## **MALLON ESTATES SUBDIVISION**

APPLICATION NUMBER 10 DATE August 21, 2003

APPLICANT Mallon Estates Subdivision

REQUEST Subdivision

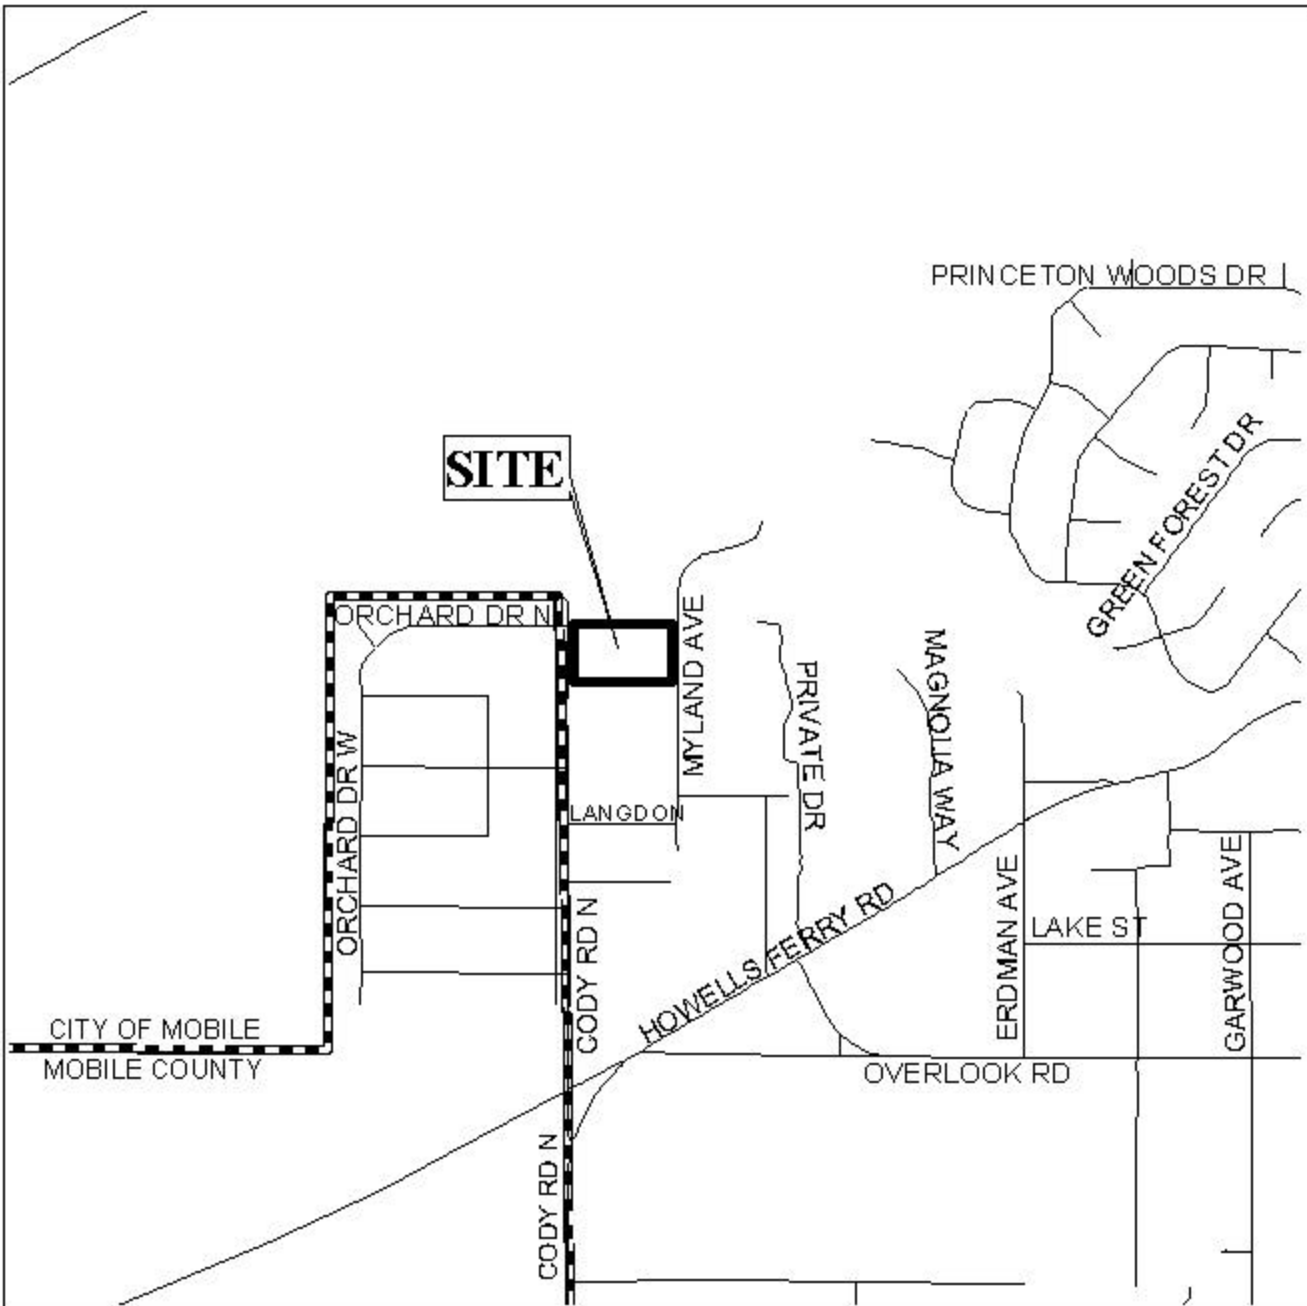
Cody Road, which is a planned major street, has an existing right-of-way in compliance with the Major Street Plan. However, as a means of access management, the placement of a note on the final plat stating that Lots B and C are limited to one curb cut each to Cody Road and Lot A is limited to one curb cut to Myland Avenue, with the location, size, and design to be approved by Traffic Engineering, should be required.

The twenty-five foot minimum setback lines are not shown but would be required on the final plat.

The plat meets the minimum requirements of the Subdivision Regulations and is recommended for Tentative Approval subject to the following conditions: 1) the placement of a note on the final plat stating that Lots B and C are limited to one curb cut each to Cody Road and Lot A is limited to one curb cut to Myland Avenue, with the location, size, and design to be approved by Traffic Engineering, should be required; and 2) the placement of the 25 foot minimum setback lines the final plat.
